TECHNICAL INFORMATION

Range H&C	Model 9100 ESFB	N° T.I. 07_2016
Serial Number 63411108	Subject STRENGTHENED ESPRESSO VALVE ASSEMBLY	N° Case N/A

New Espresso valve assembly version

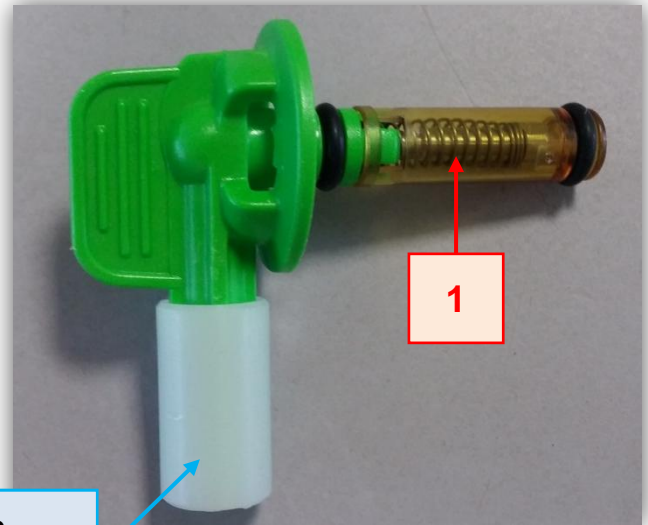
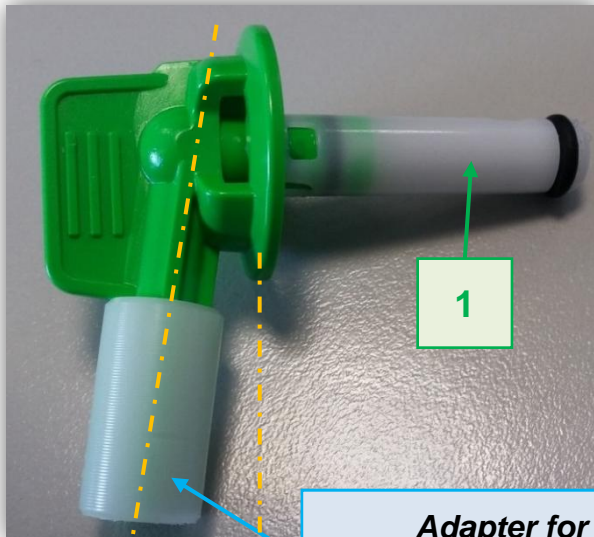
Be informed that the ESPRESSO VALVE ASSEMBLY, for ESFB versions, has been modified, starting from: S/N **63411108 (9100)**.

The main reason of the modification is to improve the reliability of the components, with the improved material, avoiding any damage during the brewer maintenance

1. The inlet **ES valve angle** has been modified to avoid any rubbing of the inlet hose with Z4000.
2. The component "**1**" *material and design* have been modified to improve the sealing.

New Espresso valve assembly version The spare part code is: **260549 (55116882)**
It includes also the adapter for ES valve

Pre-modification Espresso valve assembly
The spare part code is: **259635 (55116551)**
It includes also the adapter for ES valve
